Item Name: Crosstube Assembly, Mid Fwd

DART AEROSPACE LTD	Work Order: 132343
Description: Crosstube Assembly, Mid Fwd	Part Number: D206-667-147
Inspection Dwg: D206-667-147 Rev: A	Page 1 of 2

DART AEROSPACE LTD HAWKESBURY, ONTARIO, CANADA	
DRAWING NO. D206-667-147	REV. A SHEET 1 OF 4
TITLE CROSSTUBE ASS'Y (206L MID FWD)	SCALE NTS

DRAWING NO. D206-667-147	TITLE CROSSTUBE ASS'Y (206L MID FWD)	REV. A	DART AEROSPACE LTD ENGINEERING ORDER		D.E.O. NO. D206-667-147-A-1	SHEET NO. SHEET 1 OF 1	SCALE NTS
DRAWN <i>q</i>	CHECKED <i>ASS</i>	MFG. APPR. <i>JB</i>	APPROVED <i>MD</i>		DE APPR. <i>MD</i>		
DATE 11.07.15	DATE 11.07.20	DATE 11.07.21	DATE 11/07/21		DATE 11.07.21

DETAIL P
BONDING STRAP INSTALLATION 2 PL

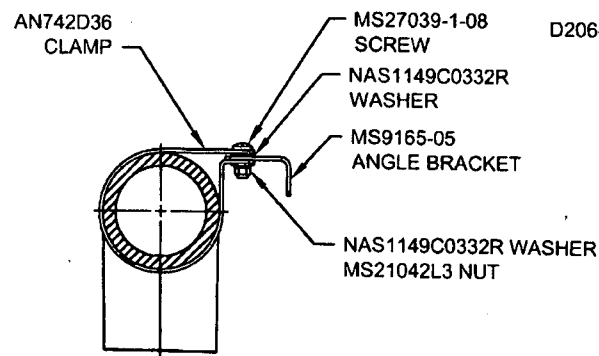
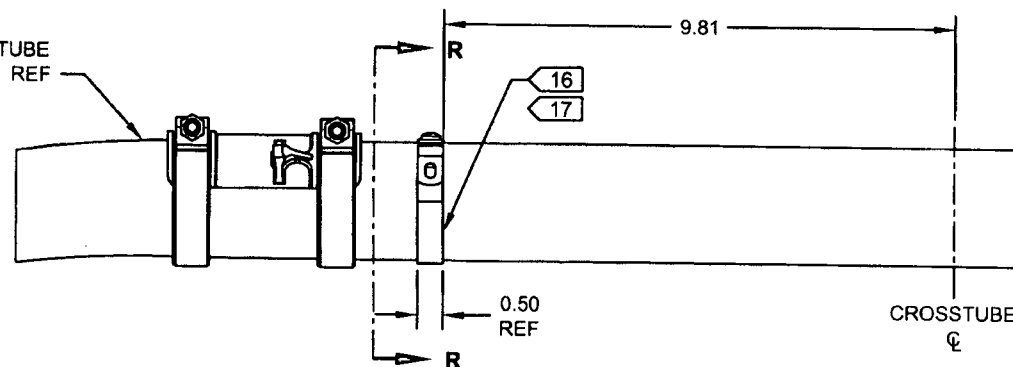
ADD ELECTRICAL GROUNDING STRAP

ITEM	QTY -147	PART NUMBER	DESCRIPTION
1	X	D206-667-147	CROSSTUBE ASSEMBLY (206L MID FWD)
10	2	AN742D36	CLAMP
11	2	MS9165-05	ANGLE BRACKET
12	2	MS21042L3	NUT (OR MS21042-3)
13	2	MS27039-1-08	SCREW
14	4	NAS1149C0332R	WASHER (OR AN960C10L)

- 16) MASK AREA UNDER CLAMP PRIOR TO PAINTING
- 17) SEAL EDGES WHERE AN742D36 CLAMP MEETS WITH THE CROSSTUBE USING SIKAFLEX-241/-291 OR MIL-S-8802 CLASS B2 OR PROSEAL 890 SEALANT
- 18) PERFORM RESISTANCE CHECK TO ENSURE MAX RESISTANCE IS 10 MILLIOHMS
